Kinetis 100 MHz Rev 1.x to Rev 2.x Migration Guide

This document shows differences and describes the details of migrating from Kinetis 100 MHz Rev. 1.x to Rev. 2.x.

Figure 1. PMC_REGSC

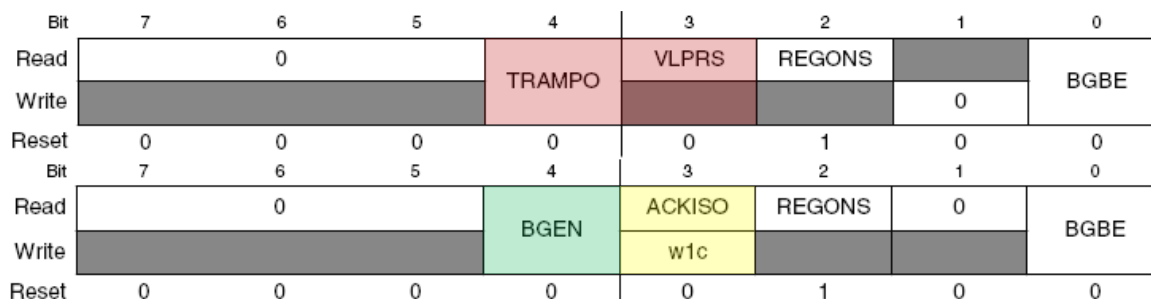
- TRAMPO—Removed in Kinetis 100 MHz Rev. 2.x/120 MHz
- VLPRS—Removed in Kinetis 100 MHz Rev. 2.x/120 MHz
- BGBE—Bandgap Buffer Enable

TRAMPO: The TRAMPO bit has been removed. There is a new bit in the SMC—RAM2PO—that controls the RAM power in VLLS2. The new RAM2PO bit has different functionality, however.

VLPRS: The VLPRS bit has been removed. Software only needs to check the Run Regulator Status and the SMC_PMSTAT register when entering VLPR mode. The REGONS bit will clear when the regulator is in stop regulation or transition to/from it and the SMC_PMSTAT will read 04 when the MCU power mode is in VLPR.

Bandgap Enable: This new bit controls the enable of the bandgap circuit. If the VREF module is operational, the BGPE bit should be set. Note that if the BGBE is set, the bandgap circuit will remain enabled and will consume current in all of the power modes. To keep the current to a minimum in the lowest power modes, this bit should be cleared prior to mode entry.

Figure 20. RNG-A block diagram

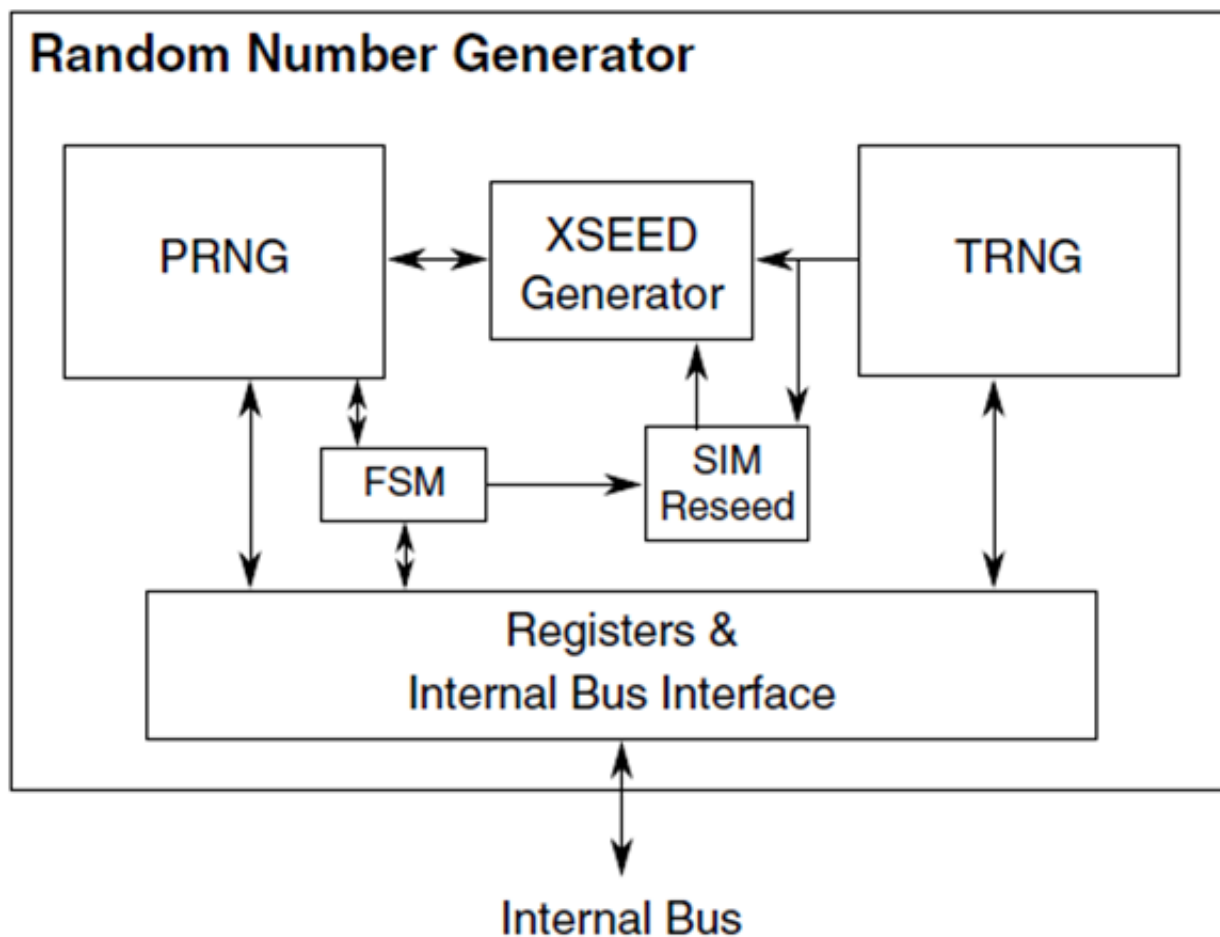
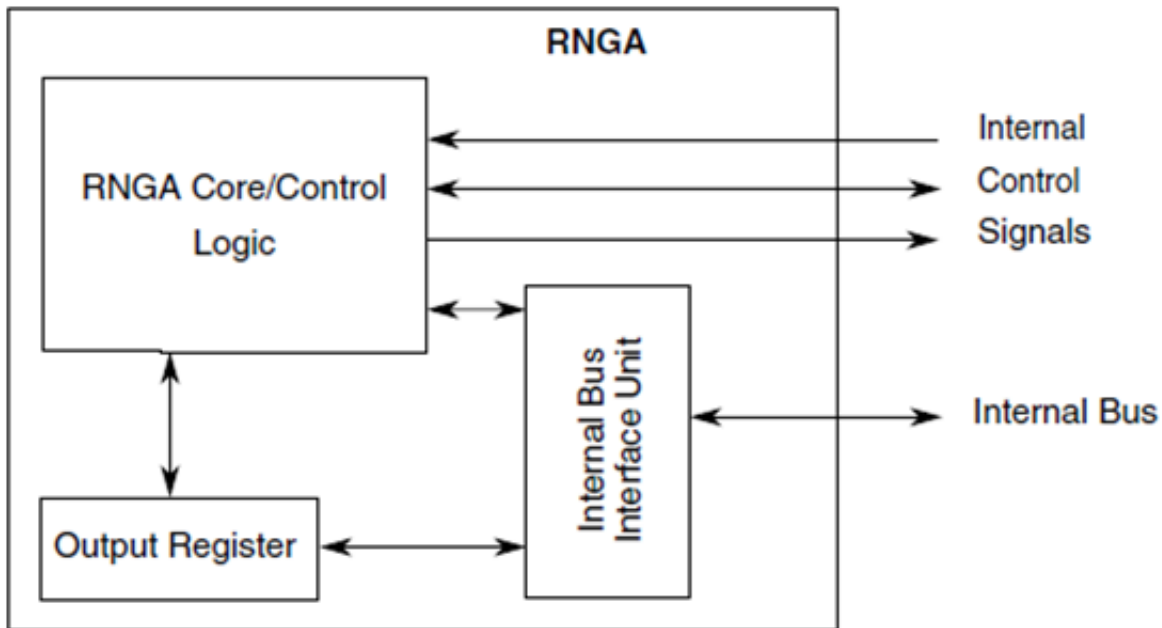
The RNG-A variant is simply a pseudo-random number generator. This module is less bulky and less complex than the RNG-B variant. The RNG-A block diagram is shown in the block diagram below.

There is no known cryptographic proof showing that this is a secure method of generating random data. Therefore, it is highly recommended that the random data produced by this module be used as an input seed to a NIST-approved (based on DES or SHA-1) pseudo-random number generator as defined in NIST Fips Pub 186-2 Appendix 3 and NIST Fips Pub SP 800-90.

Though these modules are very different internally, operationally they are very similar. The RNG-A module does not allow for manual seeding. Thus, only the automatic operation algorithms will be compared here. The two different initialization and operation modes are displayed below.

Figure 22. RNG-A module RNG_CR

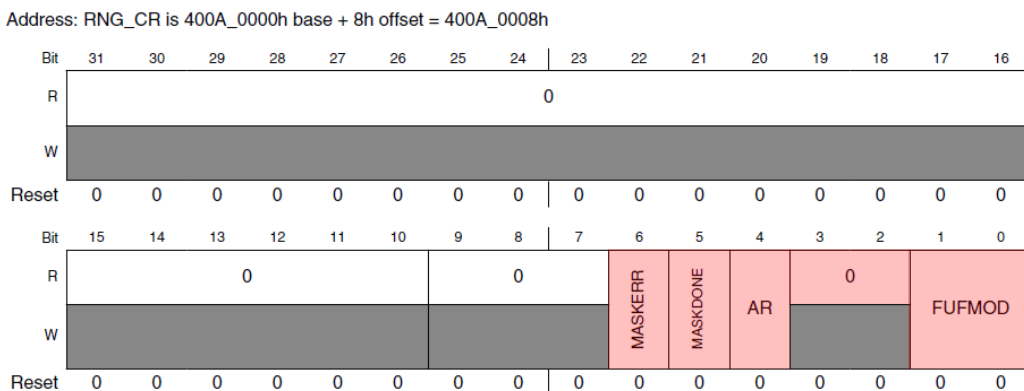
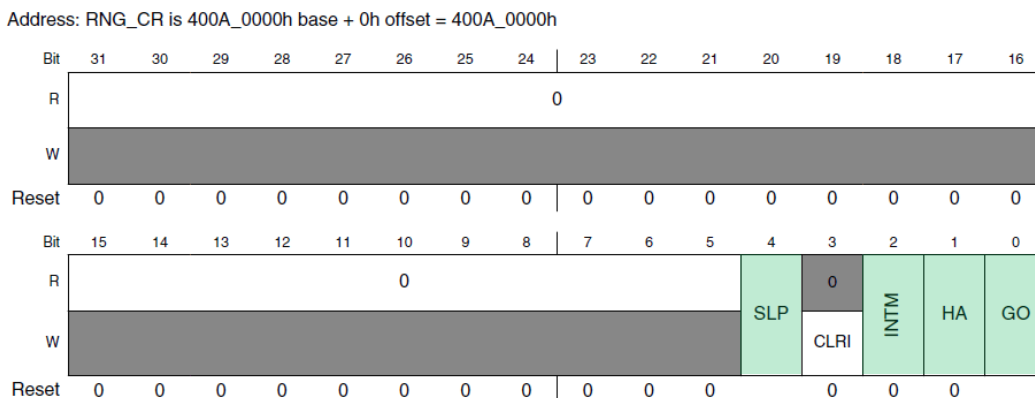
- MASKERR
- MASKDONE
- AR
- FUFMOD

- SLP: Setting this bit puts the RNG module in Sleep mode; clearing this bit awakens it.
- CLRI: Setting this bit clears the error interrupt flag.
- INTM: Setting this bit enables RNG interrupts; clearing it disables them.
- HA: Enables the security violation bit in the RNG register. Reads of the RNG register while this bit is set are not permitted.
- GO: RNG register is loaded with random data.

Figure 25. RNG-A module RNG_SR

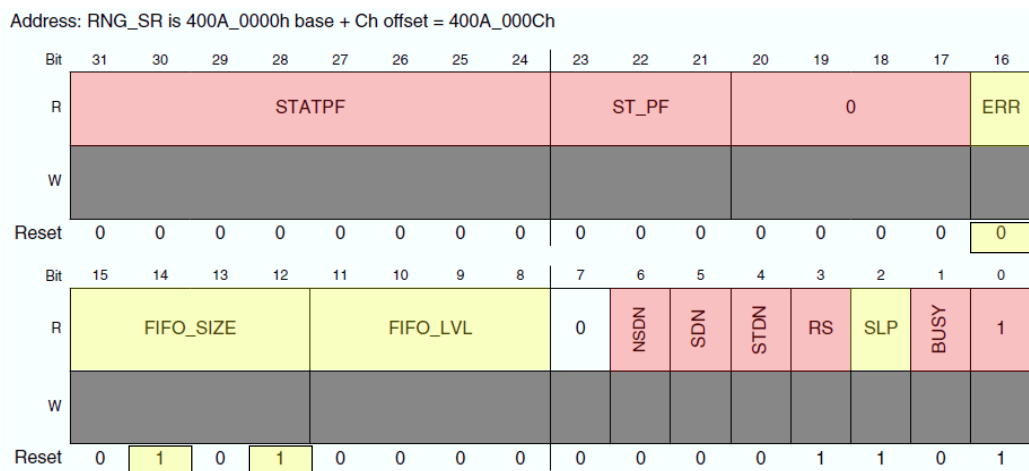
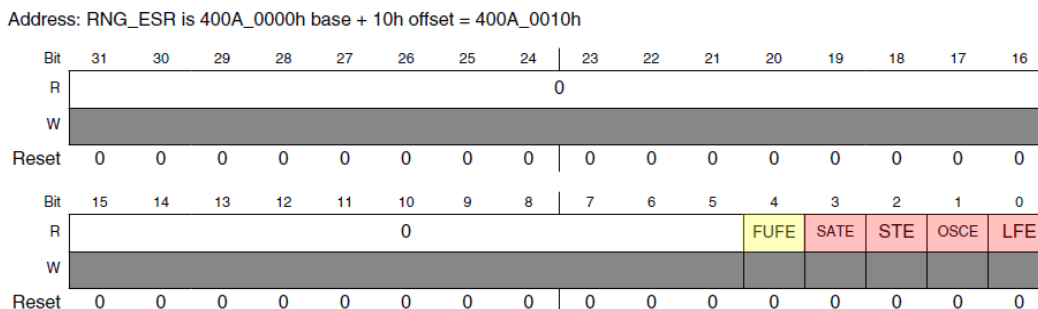
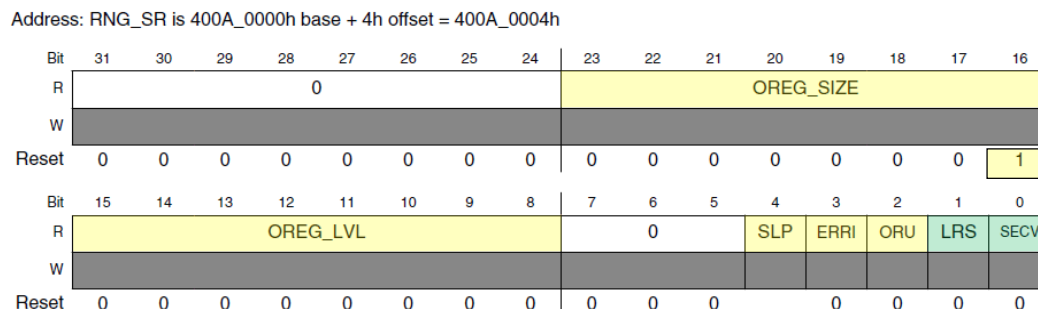
- SECV: Signals that a security violation has occurred if set. No security violation has occurred if cleared.
- LRS: When set, the last read status bit indicates that the last read was performed while the output register was empty (underflow condition).

- OREG_SIZE: This is an 8-bit integer field that indicates the size of the output register and has been renamed from FIFO_SIZE in the RNG-B variant.
- OREG_LVL: This bit indicates that a random word is available in the output register. Only two values are possible (0b00000001 or 0b00000000). This bit was renamed from FIFO_LVL in the RNG-B variant.
- SLP: Indicates that the RNG module is in Sleep mode when set. This bit was moved from bit 2 (in the RNG-B variant) to bit 4.
- ERRI: When set, this bit indicates that the output register was read while empty. This bit was moved from bit 16 (in the RNG-B variant) to bit 3.
- ORU: When set, this bit indicates that the output register was read while empty since the last read of the status register. This bit was moved from bit 4 of the ESR register (in the RNG-B variant) to bit 2.

Figure 29. I2S0_CR–Rev. 1.x

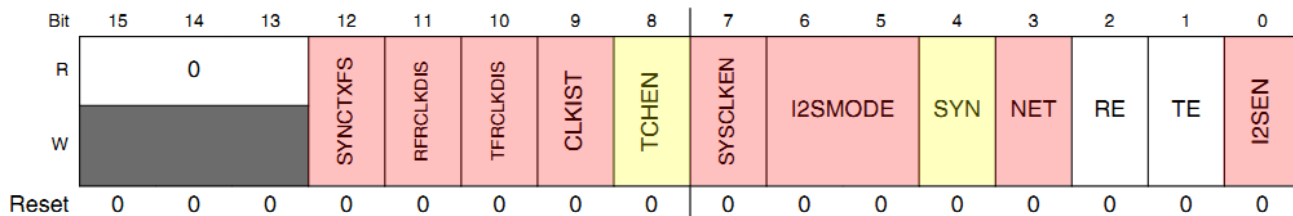
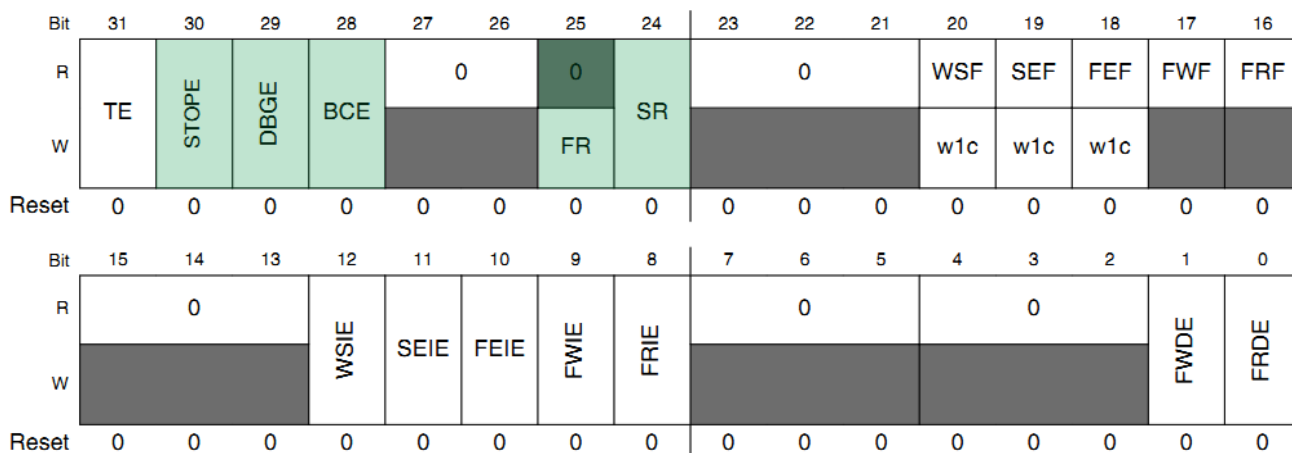
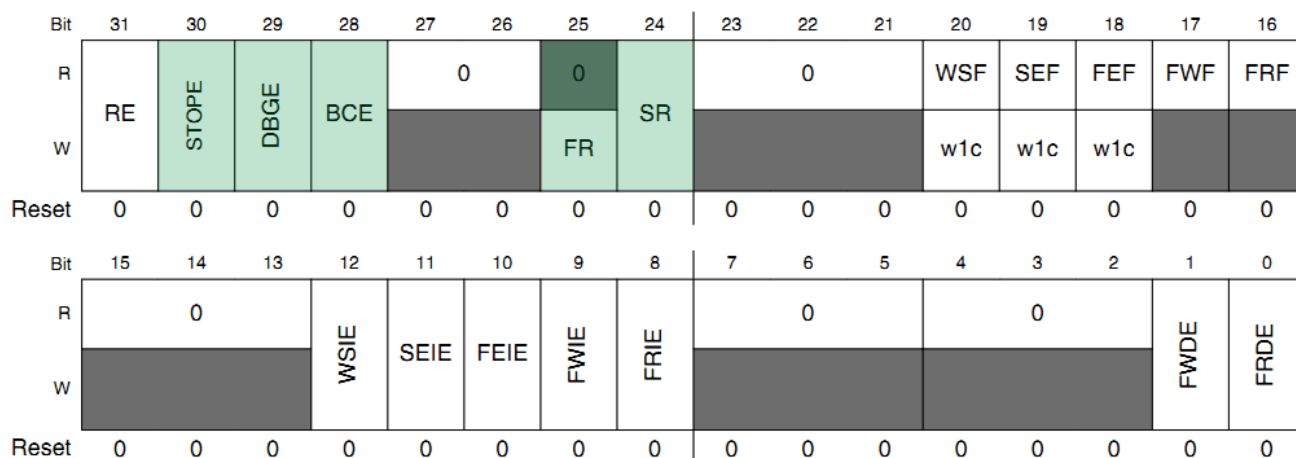
- **SYNCTXFS**: CR[TE] latch with FS occurrence
- **RFRCLKDIS**: Receive Frame Sync Disable
- **TFRCLKDIS**: Transmit Frame Sync Disable
- **CLKIST**: Clock Idle State during I2S Gated Clock Mode
- **SYSCLEN**: Oversampling Clock Enable
- **I2SMODE**: I2S Mode Select
- **NET**: Network Mode I2SEN: I2S enable

Figure 35. I2S0_ISR—Rev. 1.x

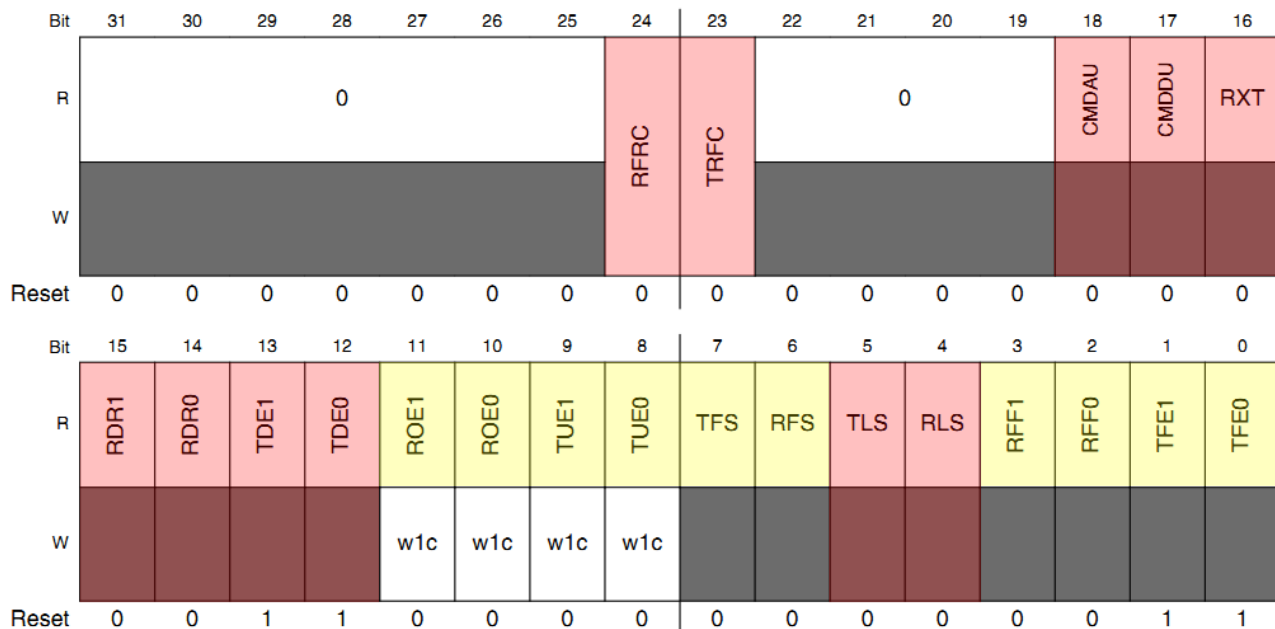
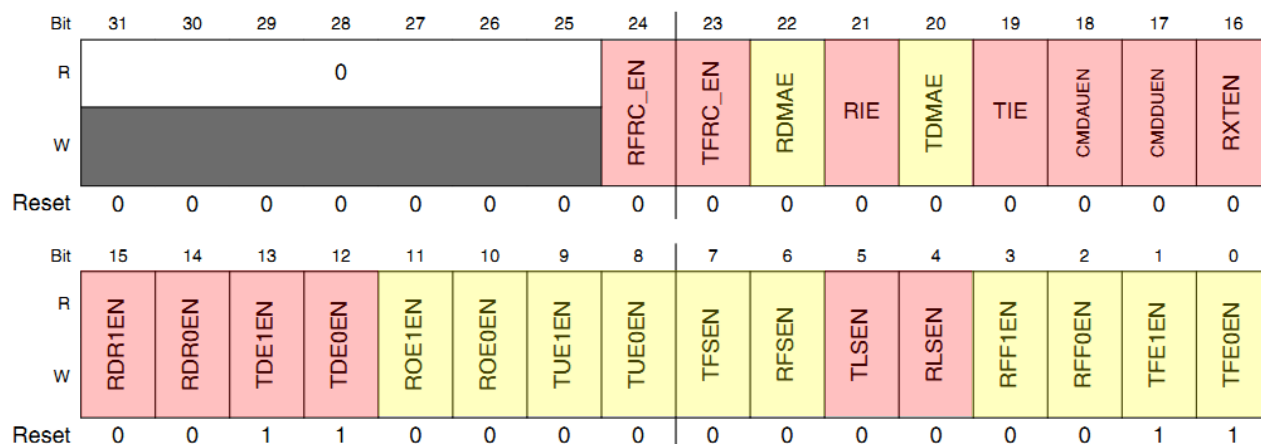
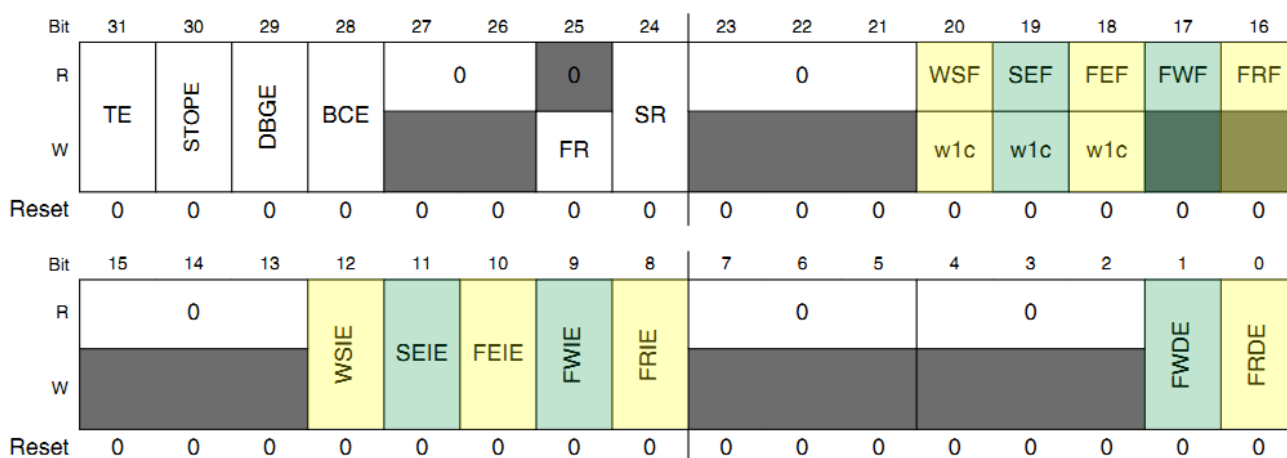
New bits/fields added:

Figure 53. SIM_SOPT2—Rev. 1.x

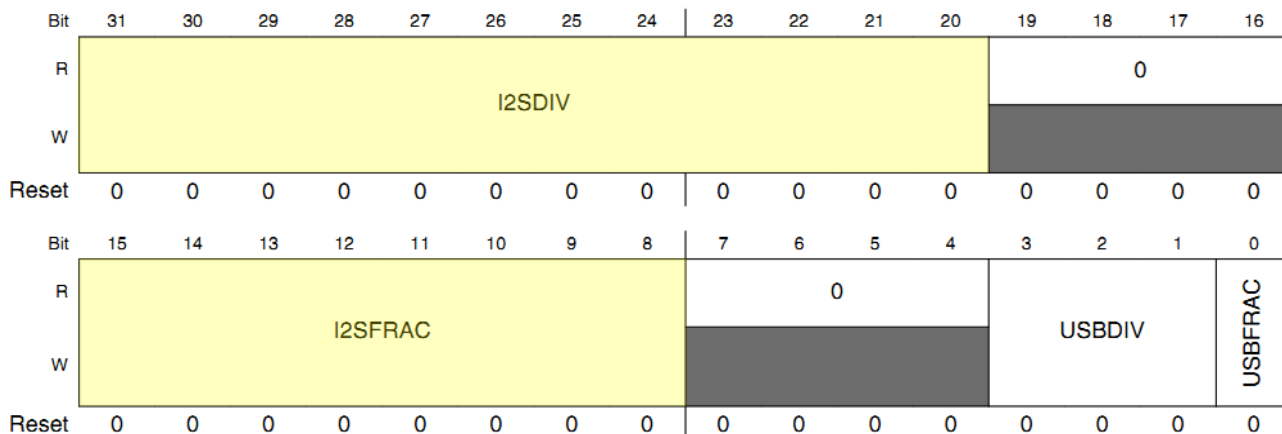
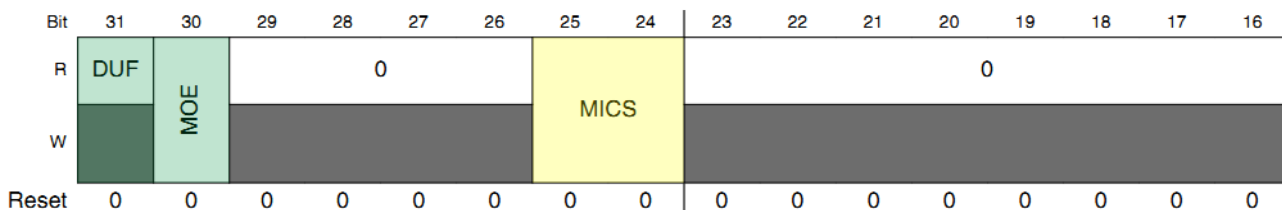
New bits/fields added:

Figure 57. SCANC registers (old and new versions)

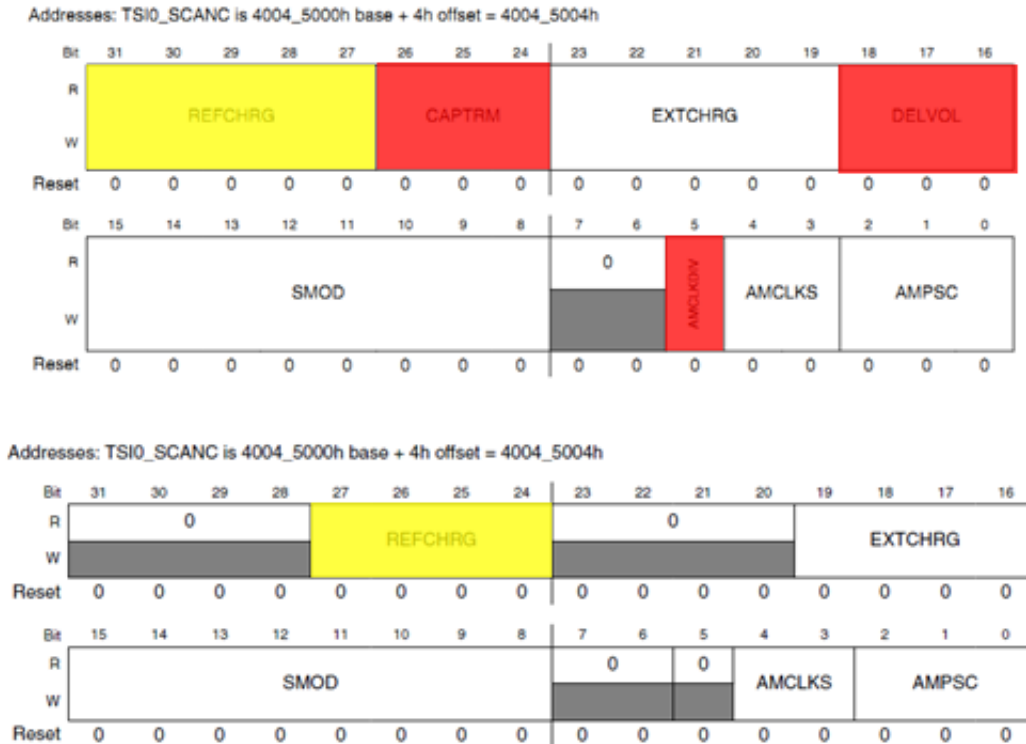
- **GENCS:** No change, but the out-of-range setting is now only operational in low-power modes.
- **SCANC:** **CAPTRM** removed (internal cap is now fixed to 1 pF), **REFCHRG** and **EXTCHRG** have been scaled down from 5 bits to 4 bits. Change involves reducing the amount of possible current values from 32 to 16. Current range is now from 2 μ A to 32 μ A in increments of 2. **DELVOL** eliminated, delta voltage value is now fixed. **AMCLKS** clock sources changed: bus clock reference was changed for **LPOCLK**. **AMCLKSDIV** was also removed because it was only practical with bus clock as reference. Instead of dividing down the clock source, now a slower, lower power source can be used. This reduces overall power consumption of the module. If a slow source is needed, use **LPOCLOCK** and adjust with **AMPSC**. If a faster source is needed, use **MCGLRCLK** or **OSCERCLK**.
